**PLANNING DIVISION REPORT
DEPARTMENT OF PLANNING AND COMMUNITY
AND ECONOMIC DEVELOPMENT
Of July 3, 2007**

RE: I.D. # 06574: Zoning Map Amendment LD. 3273 To Rezone 8001 Raymond Road from Temp. A to O1 and I.D. #06866, Approval of a Two-Lot Certified Survey Map of the Same

1. Requested Actions: Approval of a request to rezone 5.45 acres of the property addressed 8001 Raymond Road from Temporary A (Agriculture District) to O1 (Limited Office-Residence District) and approval of a Certified Survey Map creating two lots. [Note: The applicant previously requested approval to rezone the same area of the site from A to **O2** (Professional Office District), but has since amended their request for **O1** zoning instead. If the Plan Commission and Common Council should approve the rezoning request, a substitute ordinance to rezone the parcel to O1 would be needed.]
2. Applicable Regulations: Section 28.12 (9) provides the process for zoning map amendments. The subdivision process is outlined in Section 16.23 (5)(b) of the Subdivision Regulations.
3. Report Prepared By: Timothy M. Parks, Planner, and other Planning Division staff.

Environmental Corridors
Central Urban Service Area Map 1
Dane County, Wisconsin
 Current as of 10/2007, updated by CAPD

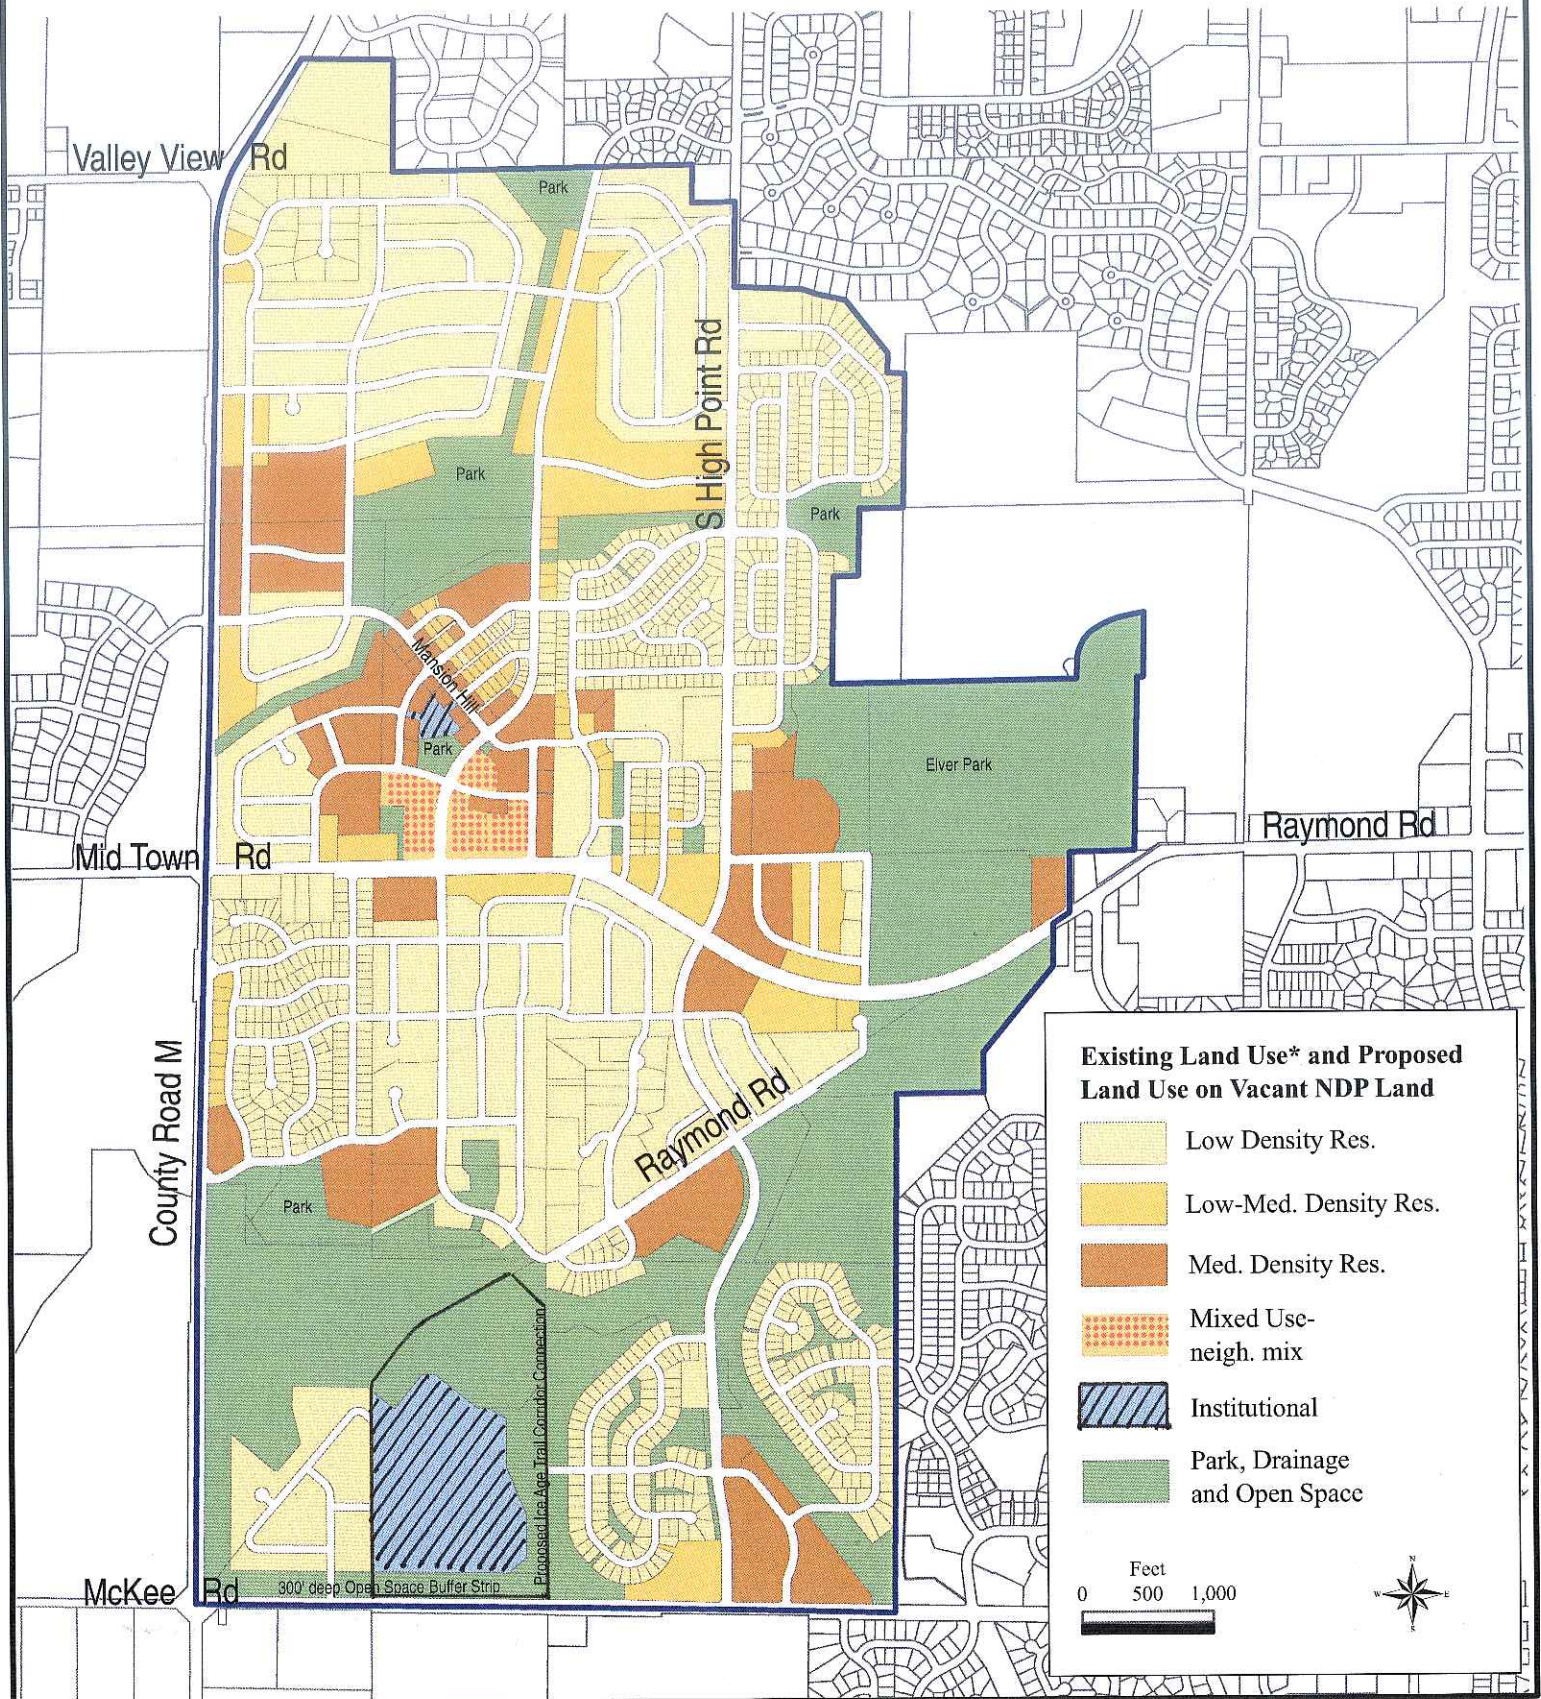
Because the 300-foot frontage landscaped buffer zone was also included in the Environmental Corridor established when the Meriter property and other nearby properties were added to the Central Urban Service Area, an amendment to the environmental corridor map to recognize the 150-foot buffer proposed with the clinic concept will also need to be approved. The resolution approving the CSM includes language allowing the City of Madison to pursue a minor alteration to the Environmental Corridor map through the Capital Area Regional Planning Commission. Except for the reduction in the depth of the landscaped buffer adjacent to the clinic site, no changes to the Environmental Corridor are recommended.

7. That the applicant receive approval from the Capital Area Regional Planning Commission staff and City of Verona for an alteration to the environmental corridor map for the reduced depth of the frontage landscaped buffer zone along McKee Road.
